New Diverging Diamond Interchange at Junction 52 Odense SV

Presentation of Road Safety Audits 2016-2018 by
Morten Klintø Hansen, Danish Road Directorate

Road Safety Audit, Step 3 Detailed design

Sharp left turns from motorway bridge

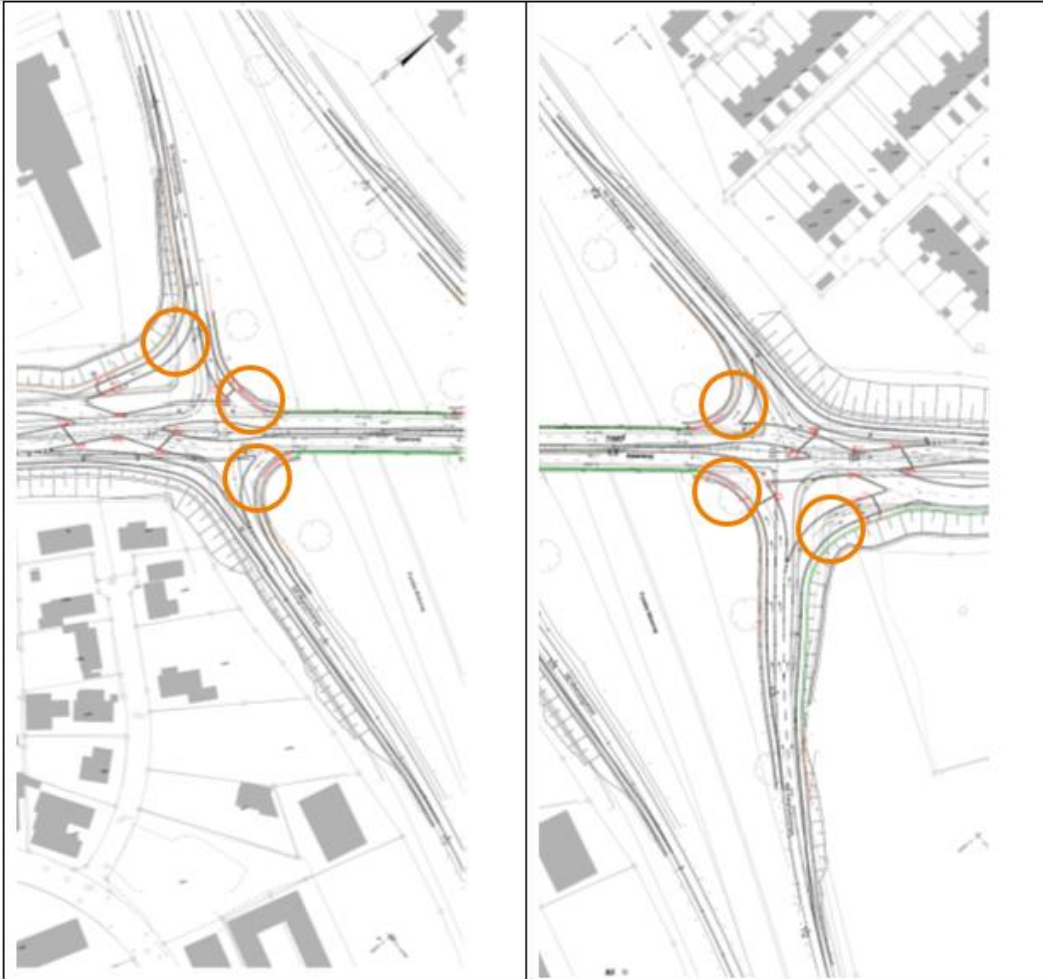
- Problem
 - Sharp horizontal curve radii for left turning towards entry ramps at end of the motorway bridge, max. speed of 30 km/h possible, no left turning lane, risk of too high approach speeds, especially in non-peak hours. This increases the risk of rear-end collisions and single vehicle accidents.
- Recommendation
 - Increase curve radii, preferably to allow for 40 km/h turning speeds.

Lack of stop sight in sharp curves

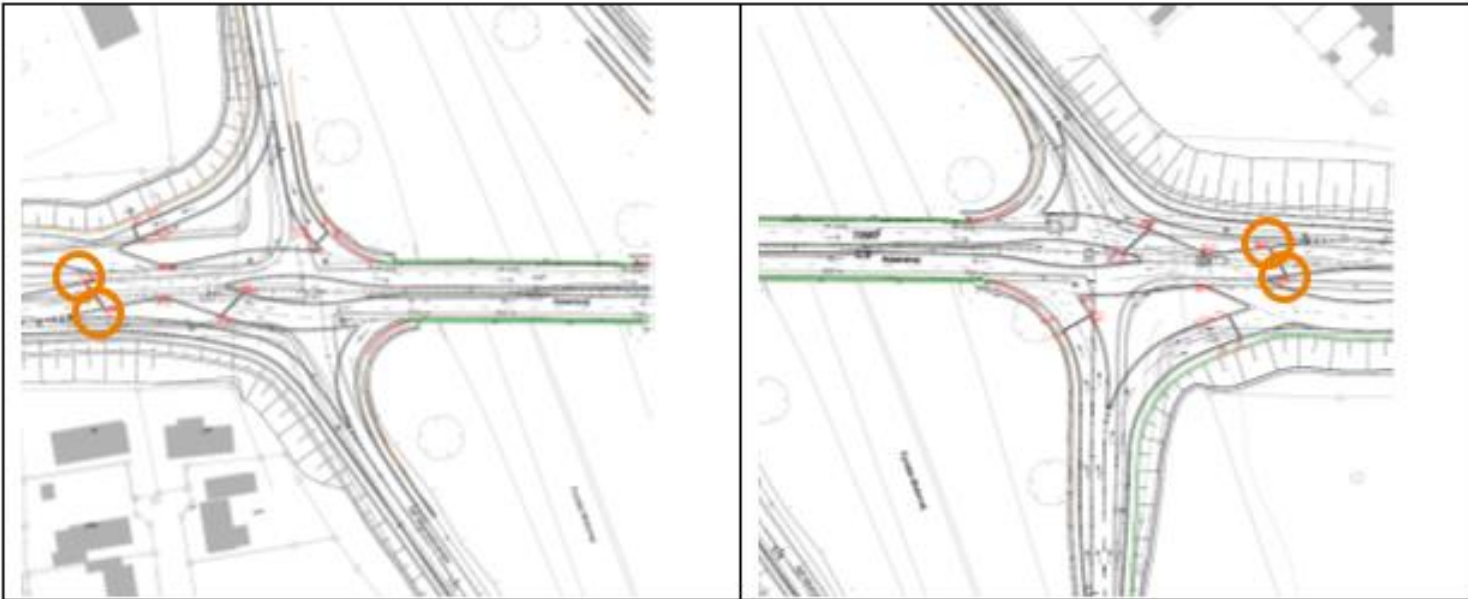
- Problem
 - In a number of sharp horizontal curves there is insufficient stop sight at the planned 40 km/h speed limit, due to combination of curve radii and new crash barriers. Especially on the exit ramps from the motorway there is a risk of much higher approach speeds. The lack of stop sight increases the risk of rear-end collisions and collisions with lost goods, etc.
- Recommendation
 - The project should provide stop sight at the design speed, as minimum the planned 40 km/h speed limit. Otherwise the speed limit should be lowered accordingly.
